Access Compliance Report

Public Rights-of-Way

(Curb Ramps)

Intersection ID: 11691	Main Street: E_18TH_ST	Cross Street: N_MCDOWELL_ST	Location: N
ADA ID: F5939CEDA465	Ramp Type: Perp	Initial Pass/Fail: Fail	Overall Compliance: No
Severity Score: 61.25			
Codes/Mitigation Info/Possible Solution		Field Measurements/Component Compliance

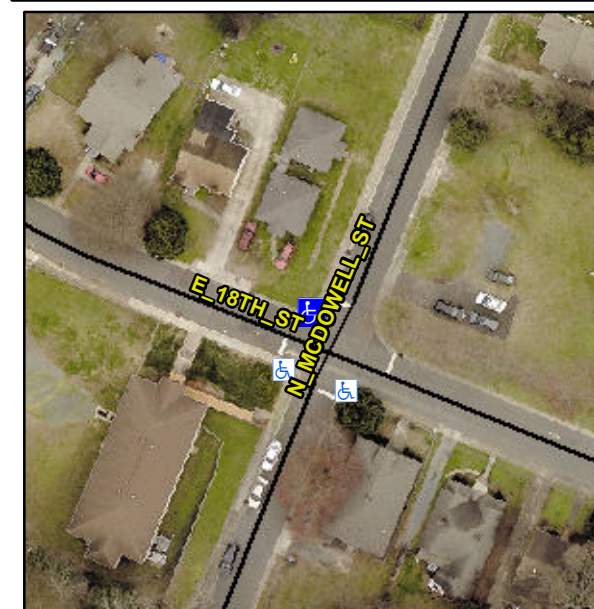
Not Found, R304.5.1, R304.2.2, R304.5.3, R302.7

Compliance	Description	Data	Compliance	Description	Data
N/A	Ramp Length (in)	69.0	No	Ramp Slope (%)	13.2
No	Ramp Width (in)	47.0	No	Ramp XSlope (%)	5.2
N/A	Flare Type LT	N/A	N/A	Flare Type RT	N/A
N/A	Flare Slope LT (%)	N/A	N/A	Flare Slope RT (%)	N/A
N/A	Flare Traversable LT?	N/A	N/A	Flare Traversable RT?	N/A
N/A	Landing Length (in)	N/A	N/A	DWS Provided?	N/A
N/A	Landing Width (in)	N/A	N/A	DWS Contrast?	N/A
N/A	Landing Slope (%)	N/A	N/A	DWS Length (in)	N/A
N/A	Landing X Slope (%)	N/A	N/A	DWS Full Width?	N/A
N/A	Landing Curb? (Y/N)	N/A	N/A	DWS Offset (in)	N/A
N/A	Shared Landing?	N/A			
N/A	Gutter Ponding?	N/A	N/A	Gutter Slope (%)	N/A
N/A	Gutter Lip Ht (in)	N/A	N/A	Gutter X Slope (%)	N/A
N/A	Painted X Walk1?	No	N/A	Painted X Walk2?	N/A
	X Walk 1 Direction	To SW		X Walk 2 Direction	N/A
N/A	X Walk 1 Width (in)	N/A	N/A	X Walk 2 Width (in)	N/A
	X Walk 1 Slope (%)	6.3		X Walk 2 Slope (%)	N/A
	X Walk 1 X Slope (%)	6.2		X Walk 2 X Slope (%)	N/A

N/A	Ramp inside XWalk1?	N/A	N/A	Ramp inside XWalk2?	N/A
	Road Slope (%)	N/A	N/A	Clear Space?	N/A
	Road X Slope (%)	N/A	N/A	Clear Space to XWalk (in)	N/A
N/A	Any Obstructions?	N/A	N/A	Storm Grate/Utility Hazard?	N/A
	Obstruction Type			Storm Grate/Utility Type	
		N/A			N/A
		No		Surface Condition? (G/P)	Poor

Remove & Replace Entire Ramp.
